RESPONSE TO IAPUM ADVICE

Russell Vale Colliery Revised
Underground Expansion Project
MP09_0013

Prepared by
Umwelt (Australia) Pty Limited
on behalf of
Wollongong Coal Limited

Project Director: **Barbara Crossley**
Project Manager: **Gabrielle Allan**
Technical Director: **David Holmes**
Report No. **3687D/R19**
Date: **November 2020**

Figure 3: Identification and location of swamps in area of interest (SCT, 2020b) .

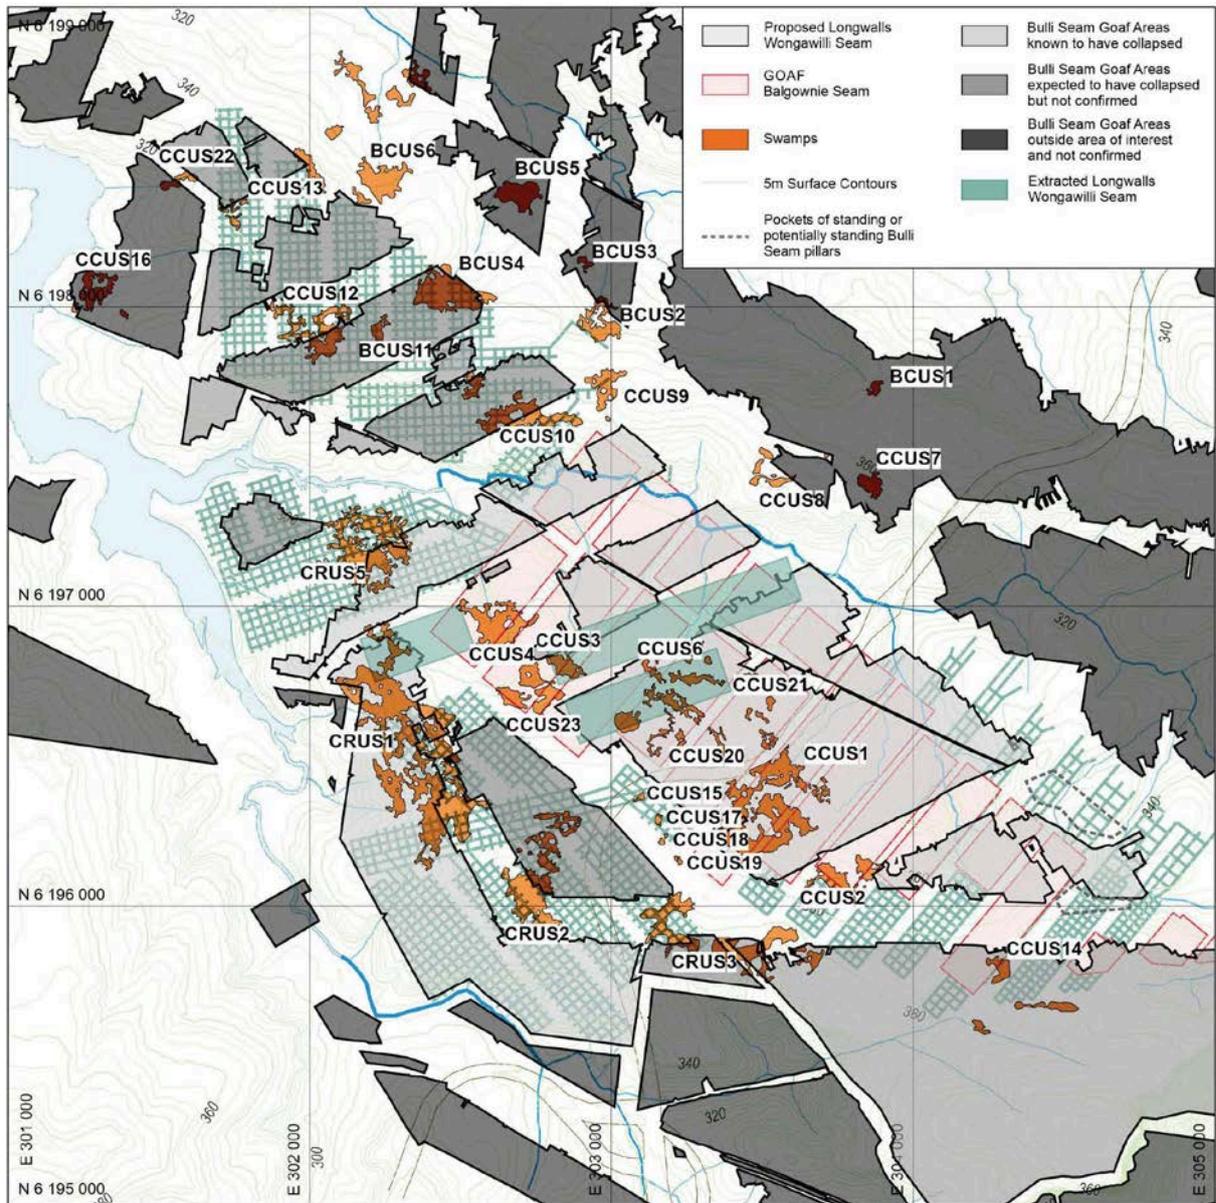
6. As a point of reference, swamp CCUS4 was a particular point of focus in the PAC's 2014 determination of the length of LW 6. The swamp lies predominantly over LW 6 as shown in Figure 3, the extraction of which was predicted to result in a maximum increase in incremental tensile strain of 11 mm/m. The 2014 PAC concluded that

Figure 1: Concept of GNSS monitoring points relative to existing goaf areas and swamp locations.

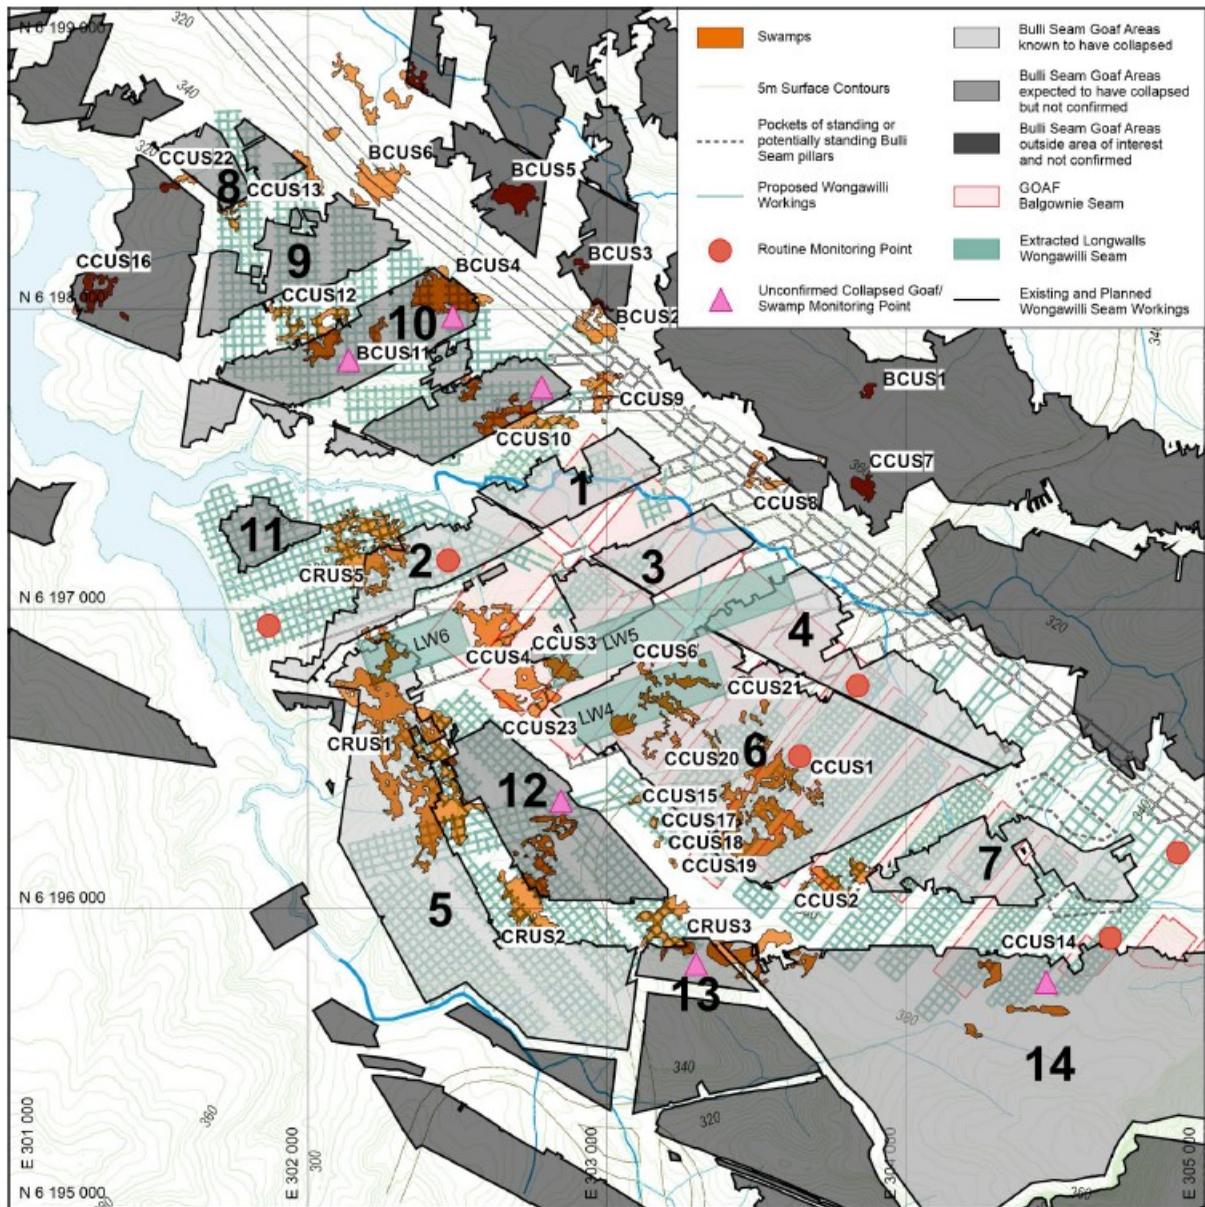
Figure 1 shows the concept of the GNSS units installed for routine monitoring of three continuous miners (CM) forming first workings in the Wongawilli Seam and the Bulli Seam goaf areas yet to be confirmed as collapsed where swamps are located above the proposed workings. The configuration shown assumes one CM unit is operating west of Longwall 6, one CM unit is mining east of Longwall 4 and one CM unit is mining at the eastern edge of the proposed mine plan area. It is recognised that three of the seven goaf areas (#8, 9 and 11) not confirmed as collapsed do not have any substantial areas of swamps above them and would not necessarily be monitored with a GNSS unit but would still be covered by the proposed InSAR technique.

As shown in Figure 1, it is intended to monitor subsidence movements above areas where it is possible there may be:

- remnant standing pillars remaining in the Bulli Seam
- the pillars have not yet been confirmed as collapsed
- and the overburden strata is not yet confirmed as fully subsided.
